Work Order ID 135088

Item Name: Replacement Skidtube, High Gear with Standard Wearplates Fits LH or RH

DRAWING NO. D2650	TITLE 206/407 SKIDTUBE ASSEMBLIES	REV. F	DART AEROSPACE LTD ENGINEERING ORDER		D.E.O. NO. D2650-F-1	SHEET NO. SHEET 1 OF 1	SCALE NTS
DRAWN <i>[Signature]</i>	CHECKED A.P.	MFG. APPR. <i>[Signature]</i>	APPROVED <i>[Signature]</i>		DE APPR. <i>[Signature]</i>		
DATE 12.10.12	DATE 12.10.22	DATE 12.10.22	DATE 12.10.22		DATE 12.10.22

CHANGE C'BORED WELDED CROSSBOLT SPACERS TO SWAGED SPACERS

AMENDMENT TO DETAIL B
NOT TO SCALE

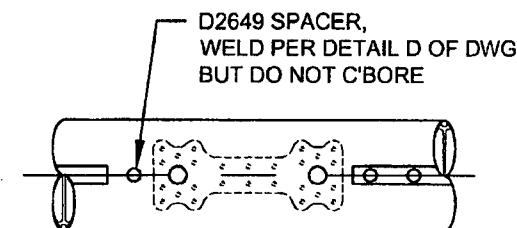
ADD DETAIL G BELOW, WHICH IS THE SAME SECTION VIEW AS DETAIL D OF DWG.
C'BORED HOLES ARE **NOW SWAGED** PER DETAIL G BELOW. FOR THE Ø0.375 HOLE THAT IS NOT C'BORED, WELD PER DETAIL D OF DWG (SEE AMENDED DETAIL B FOR REFERENCE).

DETAIL G

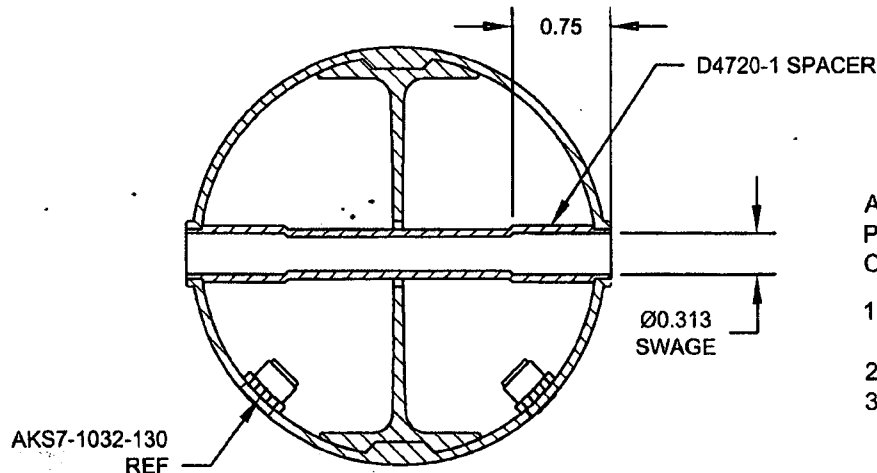
FOR Ø0.375 HOLES ONLY
FOR HOLES THAT ARE CURRENTLY C'BORED ONLY
NOT TO SCALE

AFTER DRILLING AND BENDING ASSEMBLY
PERFORM THE FOLLOWING FOR Ø0.375 HOLES THAT ARE
CURRENTLY C'BORED:

1. INSERT D4720-1 SPACER, 16 PL (-1) OR 17 PL (-3)
OR 19 PL (-5) OR 23 PL (-7)
2. SWAGE TO Ø0.313 X 0.75 DP PER QSI 002
3. TRIM / GRIND FLUSH PER QSI 002
